Transportation Impact Study Addendum

PROPOSED TEMPORARY TRUCK & TRAILER PARKING FACILITY

13291 Airport Road
Town of Caledon, ON

October 7, 2025
Project No: NT-24-207

Figure 5-2 – Left-Turn Lane Warrant

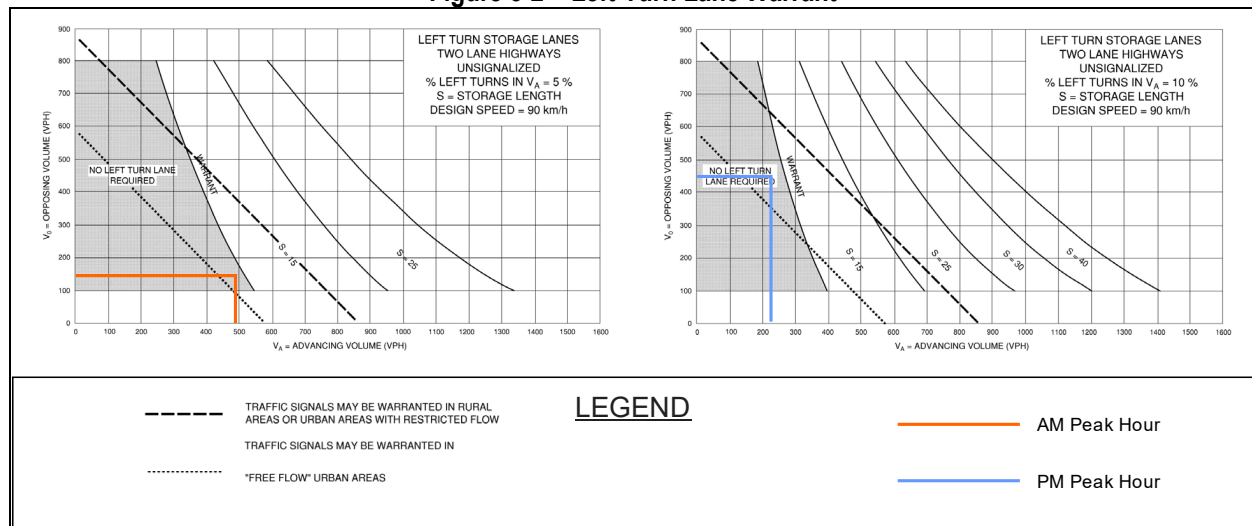
3. *Auxiliary turn lanes will be required to facilitate this development, this is triggered by total peak hour traffic and road characterization.*

NEXTRANS RESESPONSE: Nextrans maintains that the provision of an interim southbound left-turn lane at the site access would be redundant as there is an imminent road widening on Airport Road that will include a centre two-way left-turn lane. It is noted that there are a number of existing truck and trailer parking facilities along Airport Road without dedicated inbound left-turn lanes and as such, the proposed condition is consistent with established practice and is not unprecedented.

Based on the left-turn lane warrants for the subject site under existing traffic conditions + site generated traffic, neither the traffic volumes during AM peak hour nor the traffic volumes during PM peak hour warrant a left-turn lane. On this basis, Nextrans maintains that a left-turn lane for the site is not warranted under interim conditions, prior to the imminent widening of Airport Road.

Figure 5-3 – Right-Turn Lane at Site Access

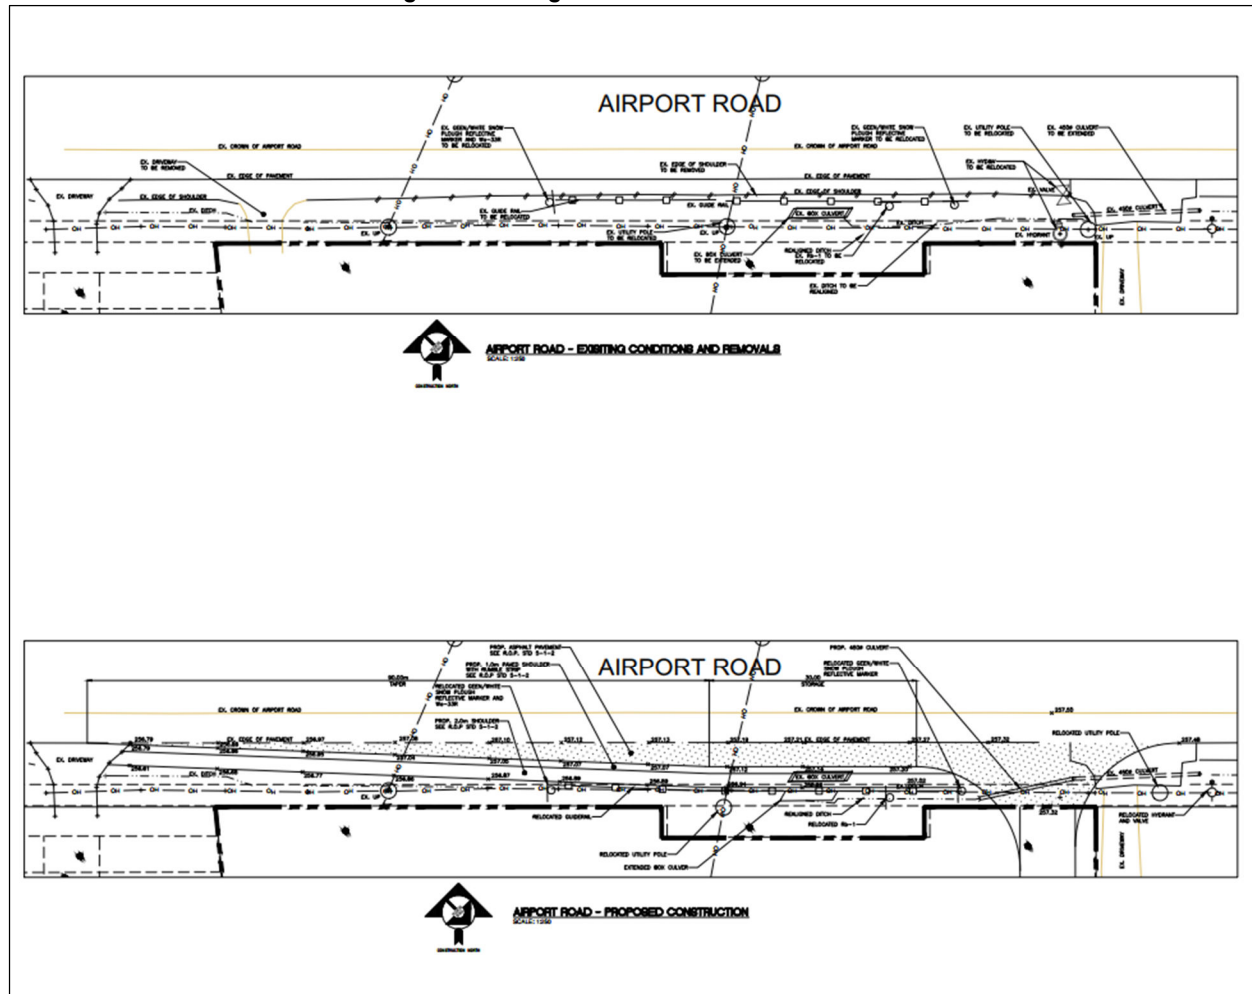
4. *The Region will require a functional design to be submitted in the forthcoming submissions which addresses the geometrics of the auxiliary southbound left turn lane and northbound right turn lane.*

NEXTRANS RESESPONSE: Please refer to Plan No. RW-1 prepared by Candevcon Group Inc.

The Owner has agreed to the construction of an interim inbound right-turn lane at the site access, acknowledging that this will eventually be removed once Airport Road is widened. The provision of the inbound right-turn lane will improve safety for all road users in the interim as it will provide inbound trucks with a dedicated lane for deceleration when turning right into the subject site. The right-turn lane was designed based on TAC 2017, Chapter 9 and the parameters are as follows:

- Right turn taper length = 90m
- Max taper width = 3.5m
- Right turn storage lane = 30m
- Curb return radius at entrance = 15m

The design of the right-turn lane was prepared by Candevcon Group Inc. and is illustrated in **Figure 5-3** below.

Figure 5-1

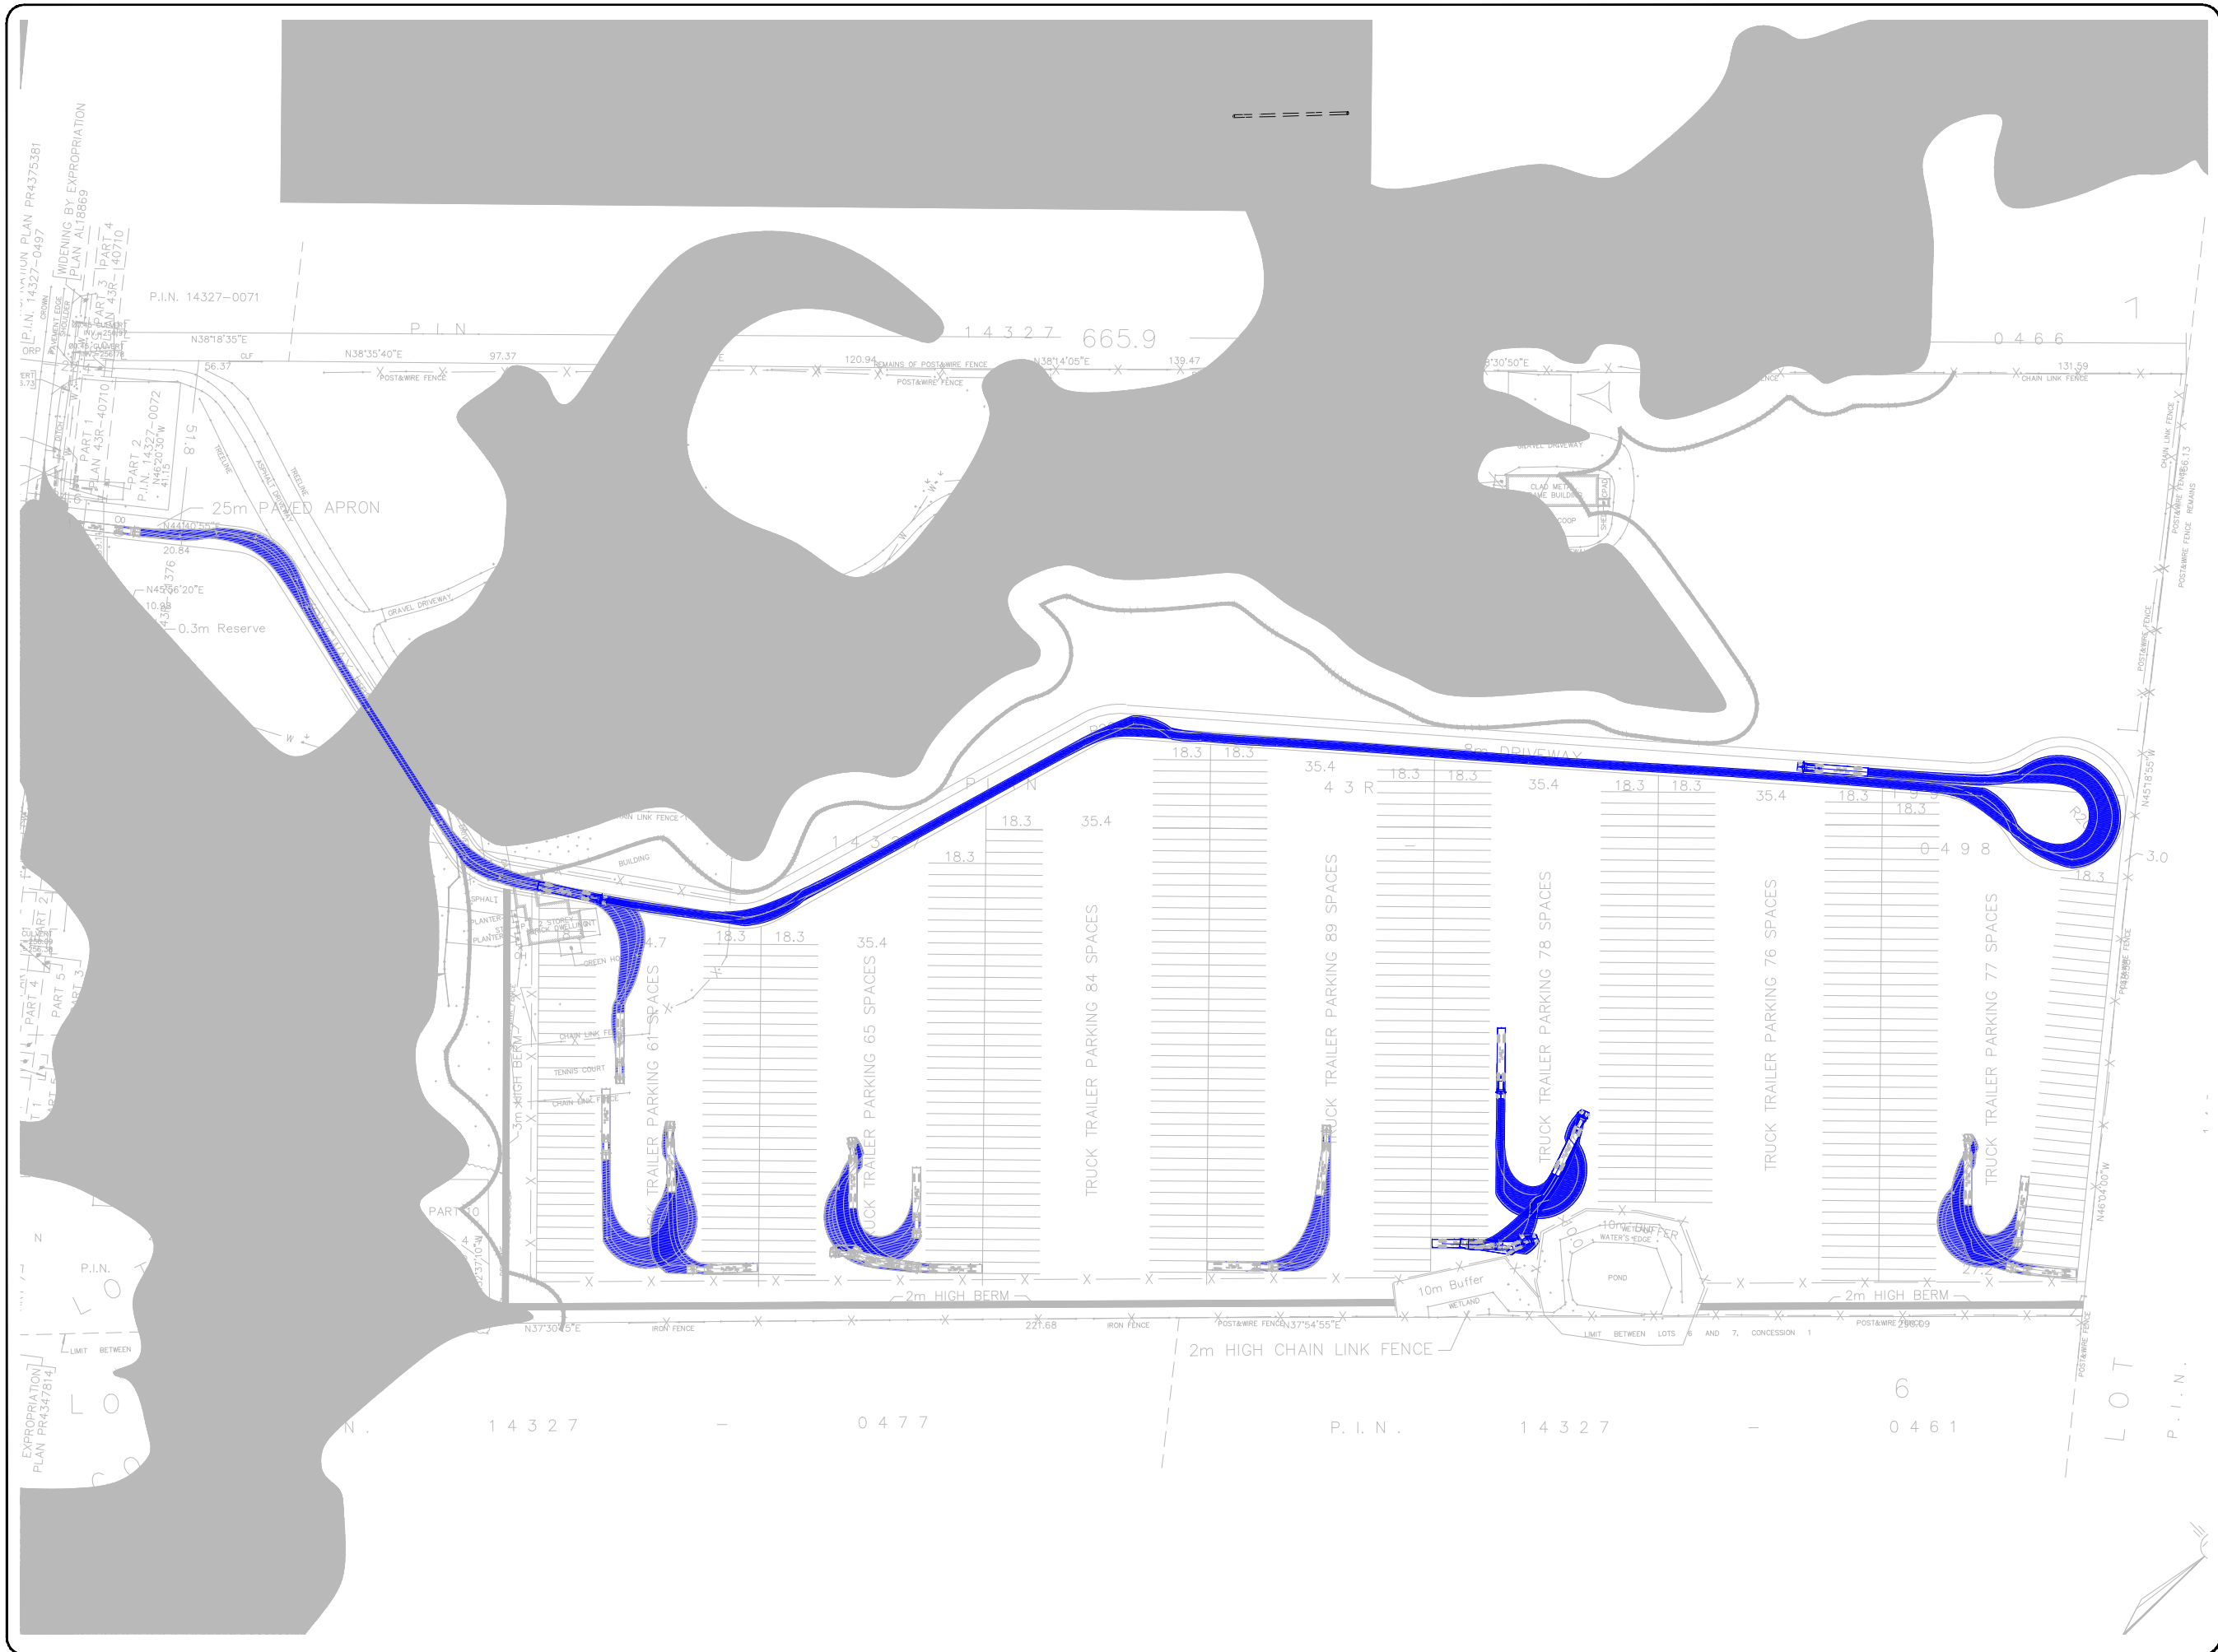
14. AutoTURN analysis should be included in the appendix.

NEXTRANS RESESPONSE: Updated AutoTURN analysis is provided in this TIS Addendum.

AutoTURN software was used to generate a vehicular turning template to confirm and demonstrate the accessibility of the proposed study area. The AutoTURN analysis demonstrates that a standard truck and trailer (WB-20 TAC-2017) can access the subject site and maneuver the proposed parking spaces. The AutoTURN analysis is provided in **Figure 5-1**.

0 Airport Road (Tullamore North-West Secondary
Plan) Site Traffic Figure

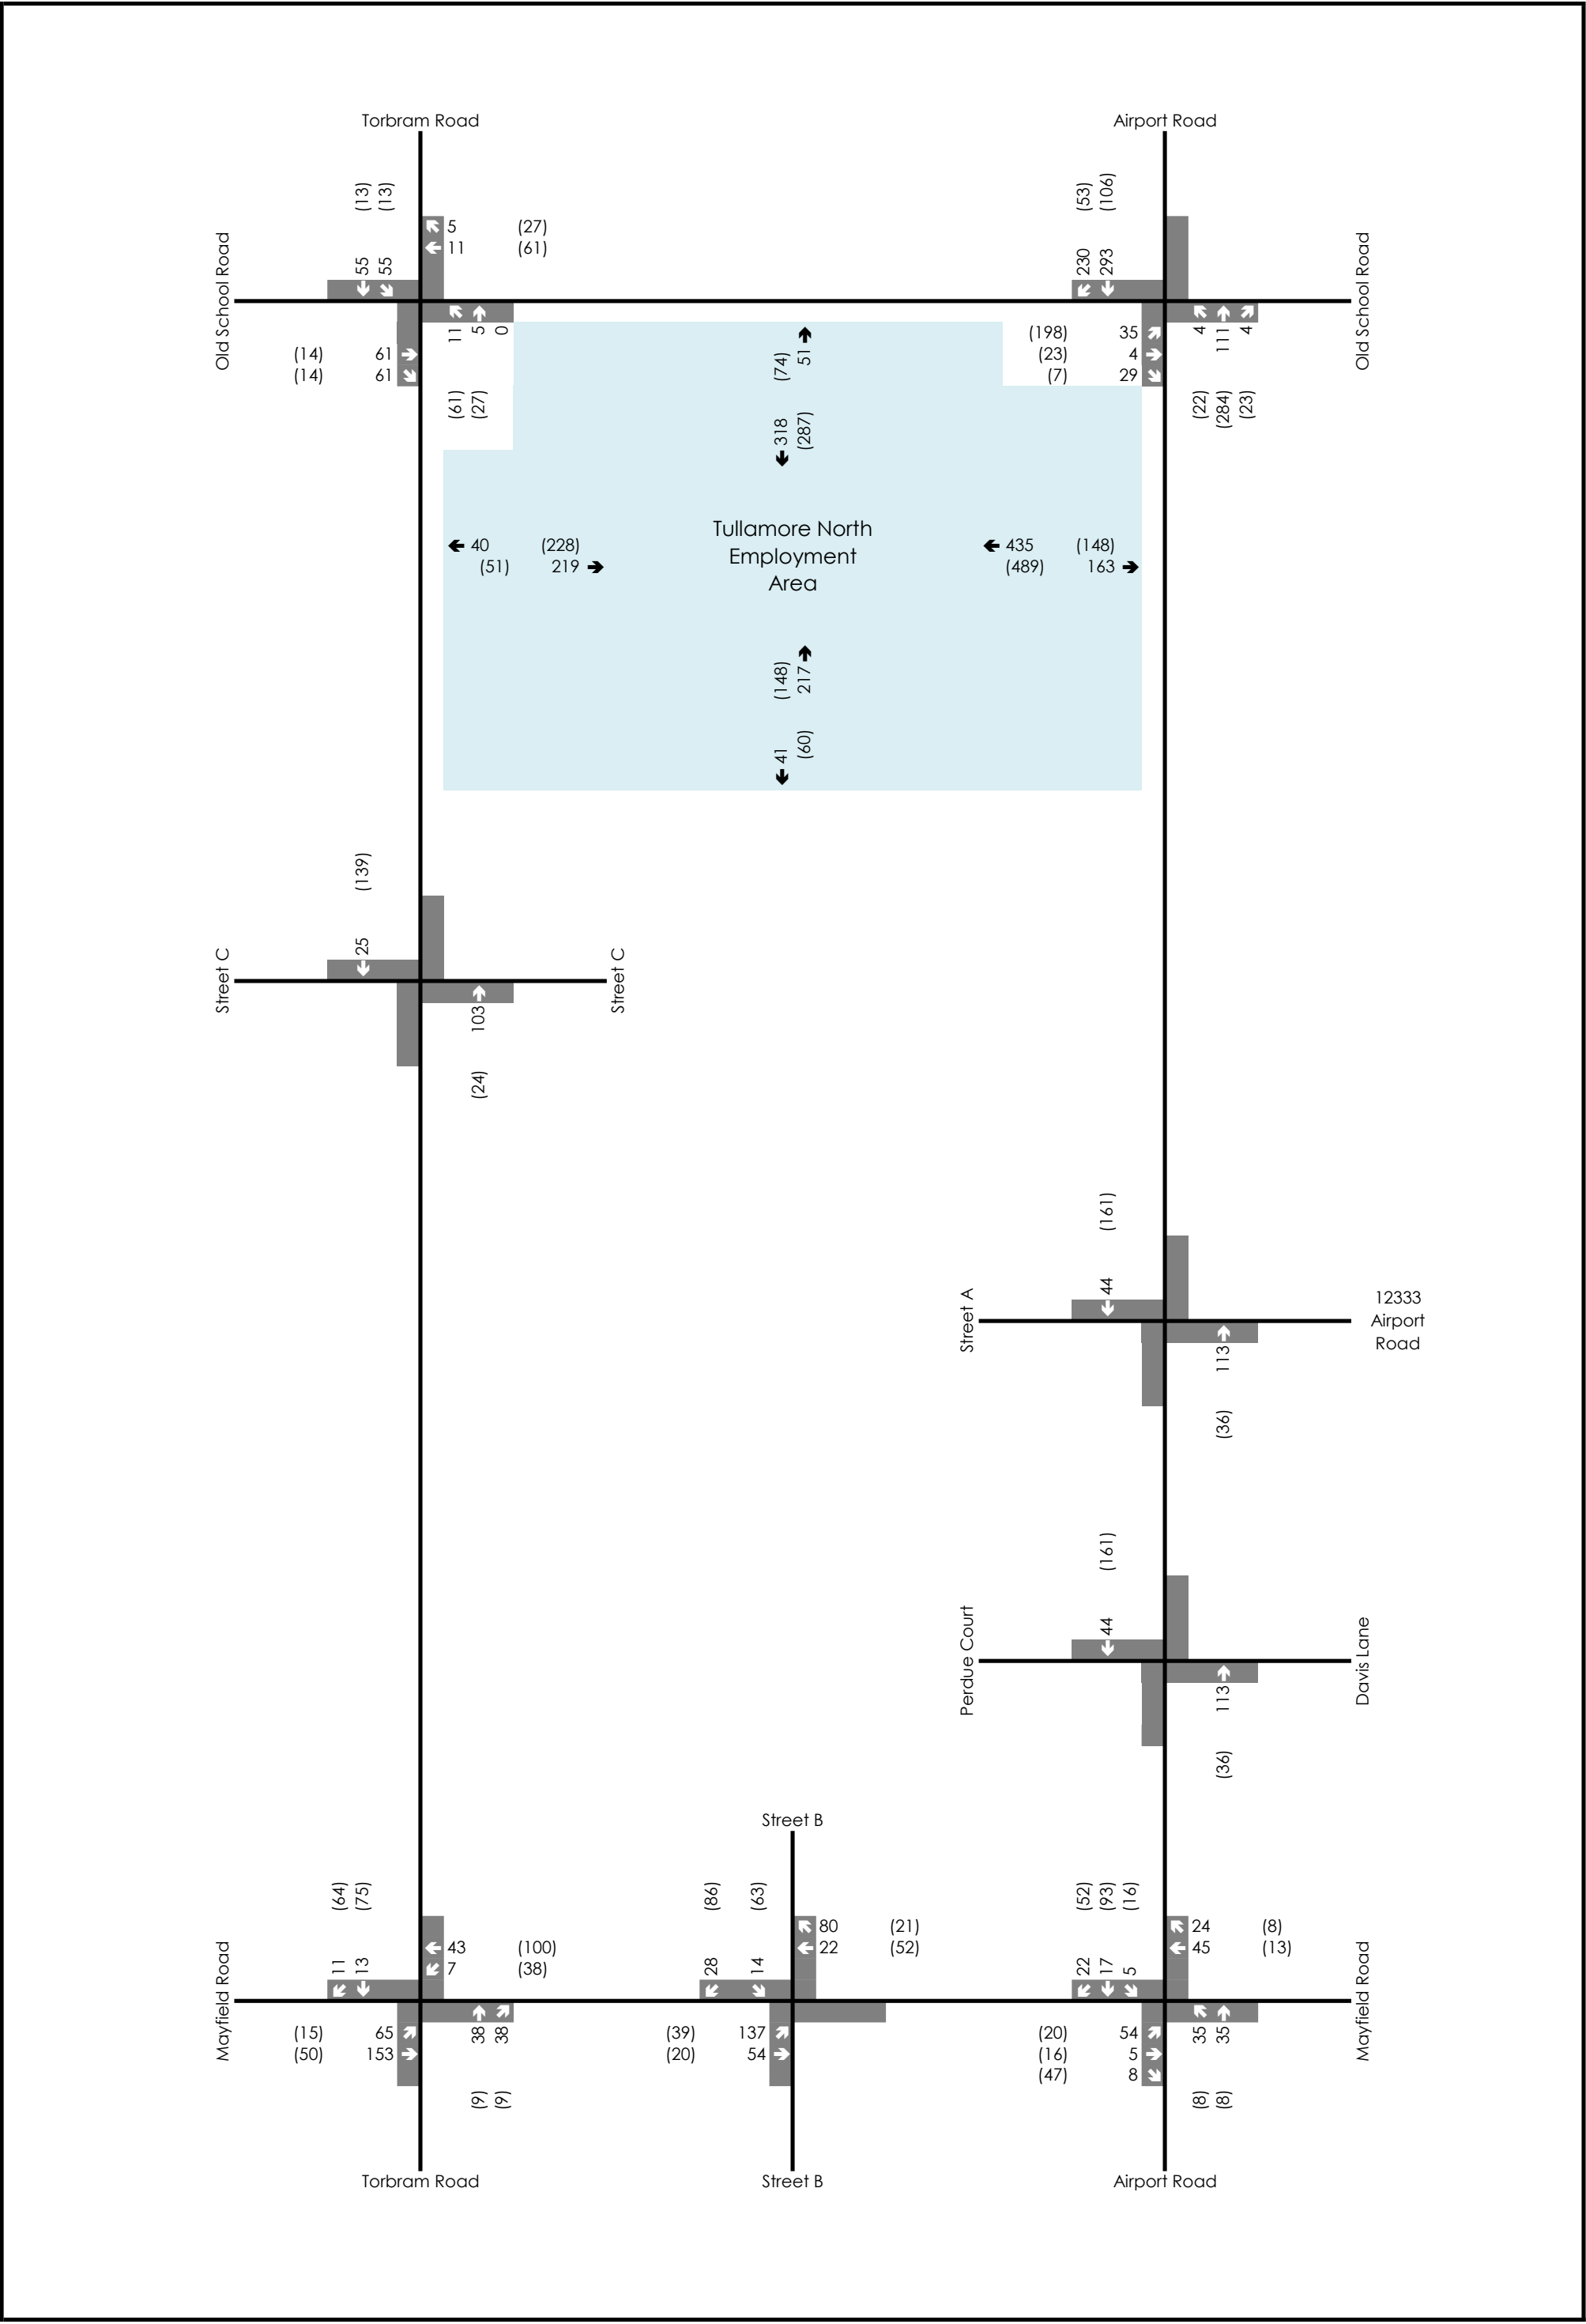
13. Since the submission of the Terms of Reference, the following secondary plan has been submitted in close proximity to the proposed development: 0 Airport Road (Tullamore North-West Secondary Plan) – Town of Caledon. If updates to the capacity analysis are required to address comments from other agencies, please consider including this plan in your review.

NEXTRANS RESESPONSE: The future background and future total traffic analyses were updated accordingly to account for the Tullamore North-West Secondary Plan and the results are provided in this Addendum.

An excerpt of site traffic figure from 0 Airport Road is enclosed in **Appendix B**.
